# 247 and 447 Series Pump Intercooler Modification

## **Product Change Notice: 12-19**

**Older Style Copper  
Finned Tube**

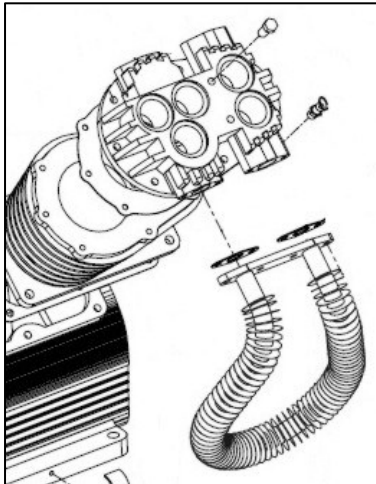
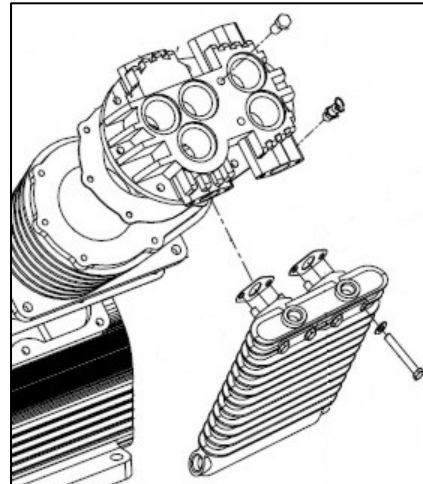
In continually improving the product, DV Systems is changing the Intercoolers as found on the '247' and '447' Pumps from the existing Copper Finned Tube to a new Cast Iron model.

The new Cooler is completely interchangeable with the existing Copper Finned Tube style, is cast iron, and simply requires (4) 3-3/4" long Hex Nuts to fasten to the Cylinder Heads.

The older Finned Tube Intercoolers will no longer be available. To replace a Finned Tube Intercooler on an existing Pump, purchase a 'KK-9865' Intercooler Kit. The Kit contains:

- (1) 447-330 Intercooler
- (2) 445-196 Gaskets
- (4) SS-01973 3/8-16 x 3-3/4" HHCS
- (4) SS-1525 3/8" Flatwasher
